TOWN OF PORTOLA VALLEY
REGULAR PLANNING COMMISSION MEETING
765 Portola Road, Portola Valley, CA 94028
Special Joint Field Meeting (time and place as listed herein)
Wednesday, May 20, 2015 – 7:30 p.m.
Council Chambers (Historic Schoolhouse)

MEMORANDUM

RE: Site Development Permit for a New Residence, Greenhouse, and Swimming Pool, File #s: 52-2014 and X9H-687, 3 Buck Meadow Drive, Ross/Tamasi Residence

PRELIMINARY CONSTRUCTION STAGING PLAN

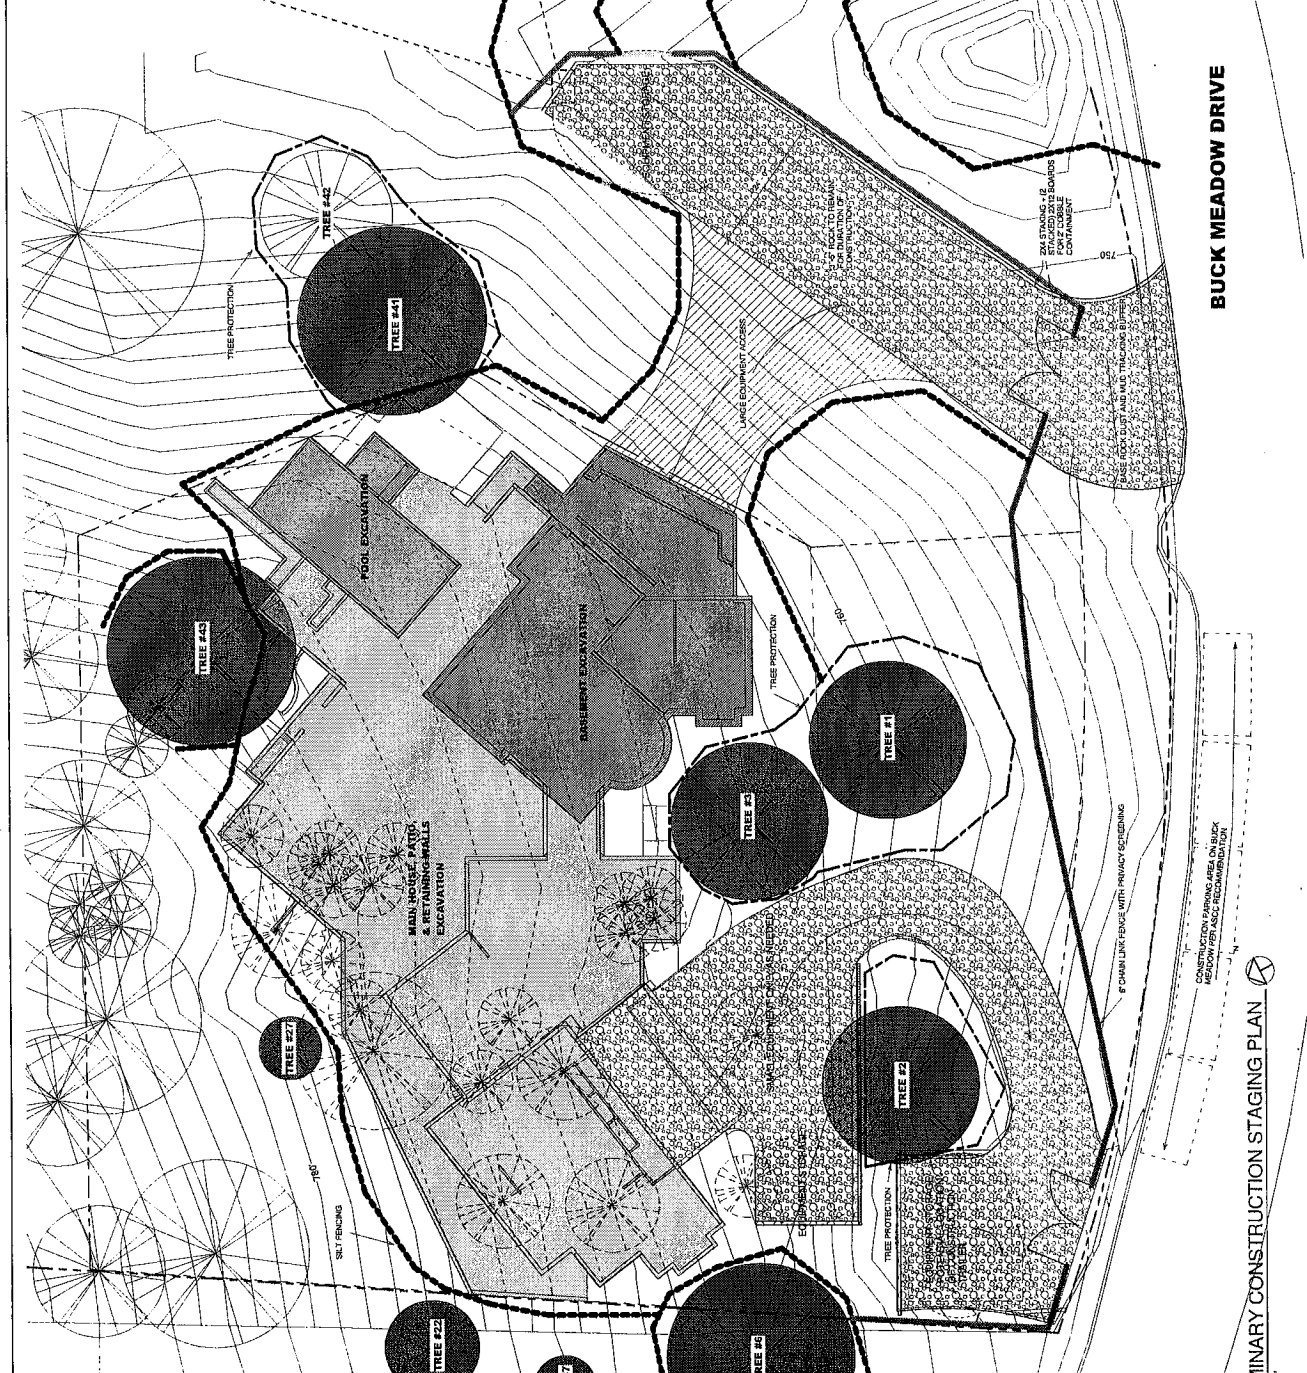
Sheet A1.02B presents a preliminary construction staging plan that proposes utilizing an area of approximately 3,900 square feet within the POSE for construction staging and large equipment access. This current plan has been revised from the plan that the ASCC reviewed on May 11, 2015 (Sheet A1.02). Specifically, in response to ASCC comments, the plan has been modified to reduce the area of the proposed staging pad by approximately 800 square feet and to shift the pad west, away from the drainage channel.

The plan calls for creating an approximately 24' x 105' access and equipment storage pad within the POSE. The proposed pad has been narrowed by approximately six feet in width and tapered at its northern end from the original proposal. Modifications were made to the pad's width in response to ASCC direction to eliminate the proposed construction vehicle parking from the pad. By maintaining parked vehicles within the new driveway staging area and on the street, it appears it might be possible to reduce the amount and duration of compaction and disturbance in the POSE. Construction of the pad would involve placement of a six- to ten-inch layer of wood chips on top of the existing grassland which would then be covered by three to five inches of base rock/cobble. Staking and 2" x 12" boards would be installed around the pad to secure it during construction.

While the plans have been modified to respond to both the ASCC and the HOA's concerns about the location of the equipment storage area of the pad within the drainage swale, further adjustments to the plan for erosion control appear necessary. As discussed in their attached letter, dated May 7, 2015, the HOA noted their concern over potential for erosion of the land

within the POSE that would impact the natural slopes and prevent the preservation and restoration of the grassland. The HOA directed the applicant to determine a solution to prevent excessive erosion and subsequent siltation onto the street. In response to these concerns, the applicant proposes silt fencing to be installed across the drainage swale. In his review of the preliminary staging plan (Attachment 15), the Public Works Director advises that silt fencing should not cross the drainage swale as shown on the plan. Instead, the plan should propose erosion control measures that ensure that no silt reaches the swale and that the swale remains fully operational, allowing the free flow of water. He advised staff that silt fencing should be installed around the perimeter of the pad to prevent erosion and straw wattles could be installed upstream of the bottom of the swale.

Some adjustments to the plan will prevent unnecessary damage to the grass area and aid the trees. The 'Tree Protective Fencing' (TPF) on Site Plan A1.02 needs to be located as outlined in my report for this project dated Thursday, February 12, 2015. Additional fencing to exclude foot traffic outside of the proposed access road and staging area should be installed and connected to 'TPF' to limit soil impacts.

- **A1.02 Construction Staging Plan & Detail** – We understand the proposed staging plan will require final approval from the Town Council. We are providing a plan to the ASCC for consideration/action so we may later illustrate to the council that the plan has been carefully reviewed and that the approach chosen to preserve significant oaks is generally supported. Further research into site sensitive methods and materials for native grass preservation is in progress, and details will be provided for building permit submittal. The plan has also been submitted to the Blue Oaks HOA.
